Appendix A: Review of London Cycle Campaign proposals for Chipping Barnet

Images to accompany report.

Brunswick Park Ward – Russell Lane

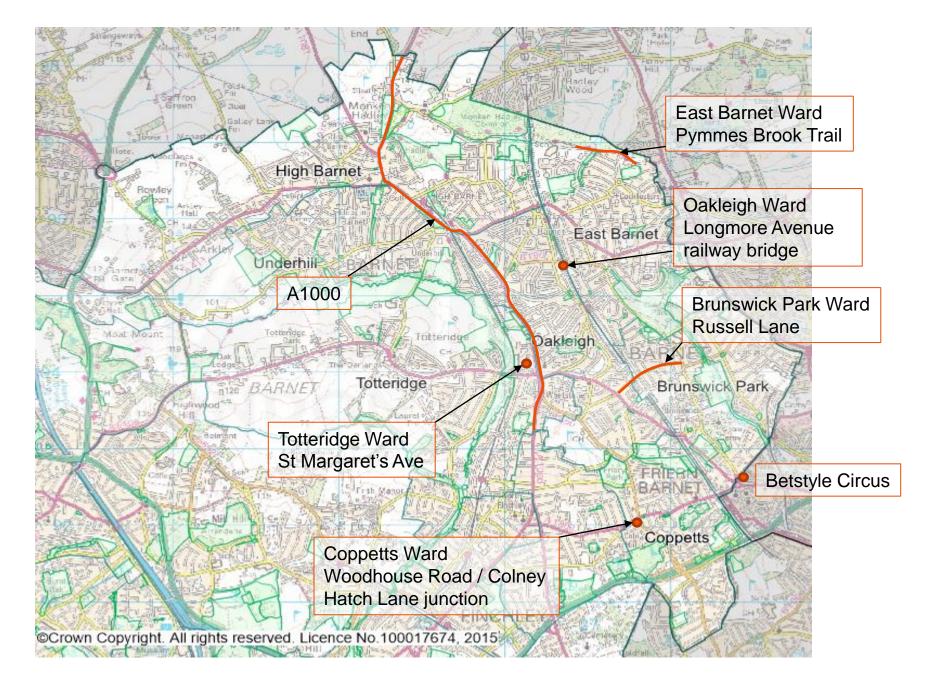
Section 1 - Kerb adjustments needed to accommodate uphill lane but possible high utility diversion costs. Parking restrictions needed.

Section 2 - A generous cycle lane and adjacent general traffic lane could be provided. Parking restrictions needed on uphill side of road.

Section 3 (Oakleigh Ward) - Flatter. Space for uphill cycle lane but parking restrictions likely to affect residents.

Coppetts Ward – Colney Hatch La / Woodhouse Road junction

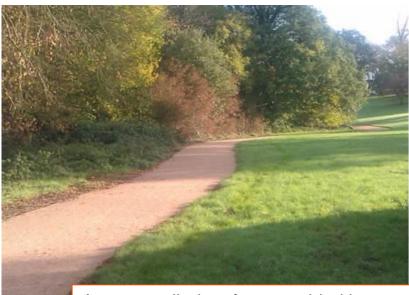
TfL receive complaints about queuing on all arms of the junction but traffic signals have been optimised as far as possible.

Bus operators have identified difficulty turning right from Woodhouse Road into Colney Hatch Lane

A1000 from south to north (1)

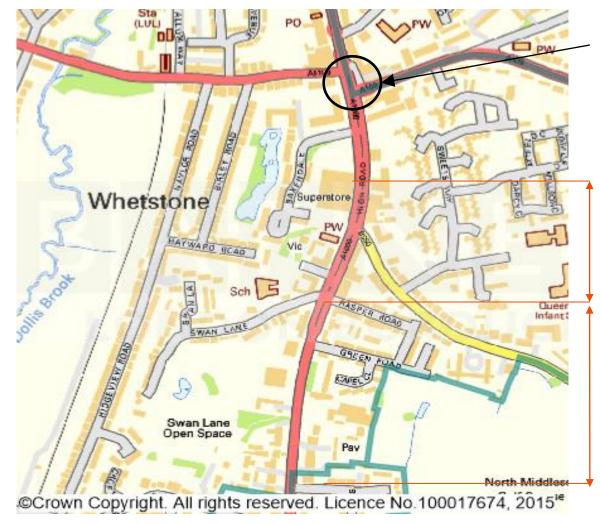
Whetstone signals – major junction improvements would be needed to make good provision for cyclists here. Alternative layouts in conjunction with redevelopment in the area may be an option.

A1000 from south to north (2)

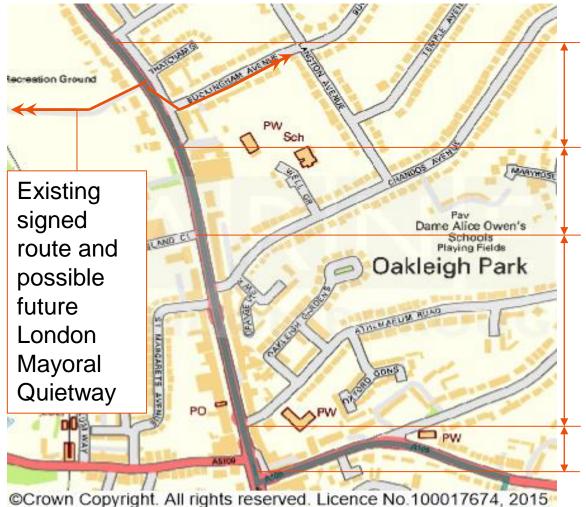
Extension of parking restrictions needed if a cycle lane is to be usable outside peak hours.

Cycle lane and general traffic lane in each direction plus permitted parking on one side of the road could be provided.

Lanes could be provided with parking retained in service road.

Some adjustments to central islands/hatching and parking.

A1000 from south to north (3)

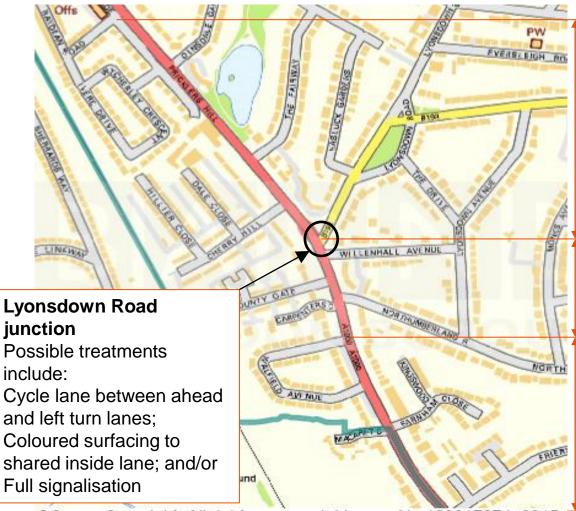
To provide a cycle lane in each direction parking would need to be restricted on one side. The wide footways might provide some alternative parking.

Removal of refuges and/or local road widening together with parking restrictions would be needed to accommodate cycle lanes.

Wide footways could help make adjustments.

A1000 from south to north (4)

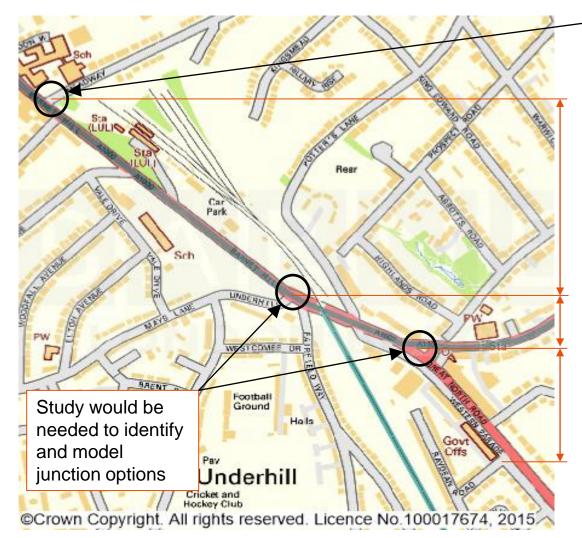
Adjustment to the central markings/ right turn areas may be needed.

With cycle lanes parking might be provided on one side of the road only in part of this area.

Limited options without serious impacts on junction operation.

Barnet Hill - Removal of the second uphill traffic lane would be needed to provide cycle lanes in both directions, which may impact of traffic flow – possibly mitigated by presence of signalised junctions both ends.

A1000 from south to north (5)

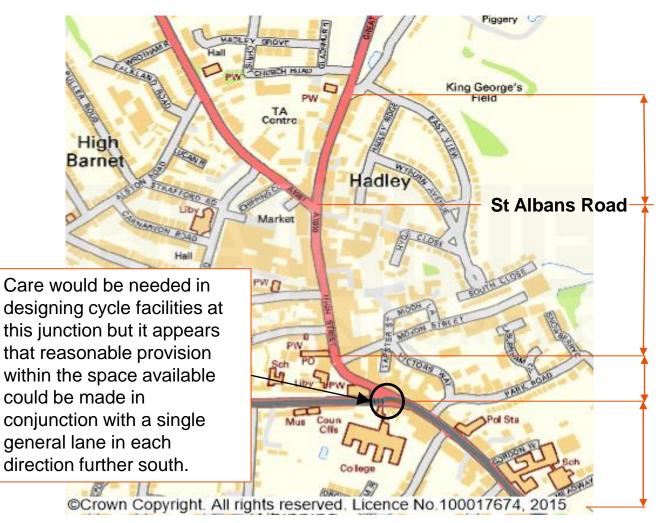
Widen carriageway & relocate refug.e

Additional parking restrictions needed and local widening to retain right turn facility.

If cycle lanes were provided only limited parking could remain. Remodelling the High Street as a 20mph environment might be a high cost alternative.

A1000 from south to north (6)

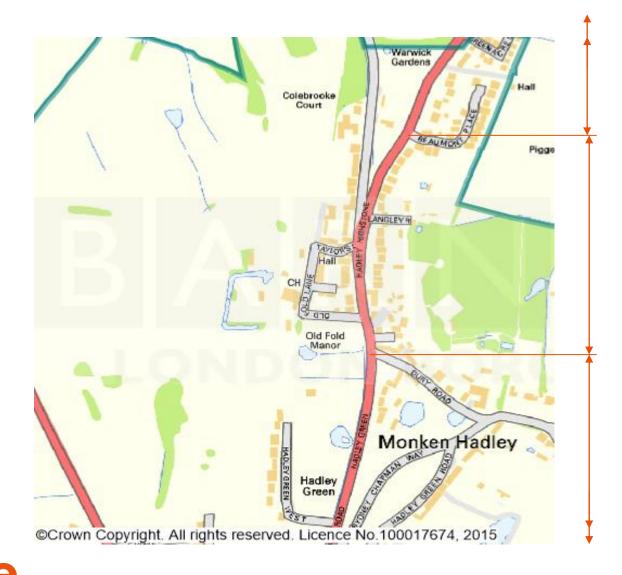
Cycles would need share space with other traffic.

Reduction to a single general traffic lane in each direction throughout would be needed.

Carriageway too narrow for lanes. Alternative routing to Potters Bar via Kitts End Road may be preferable.

Hadley Highstone – cycle lanes would affect on-street parking. If the central reserve were removed parking could be provided on one side of the road through this part, otherwise in lay-bys only.

Carriageway slightly too narrow for cycle lanes. Parking would be affected. Mitigation for a substandard layout might be investigated, or widening slightly onto green (although this may not be feasible).
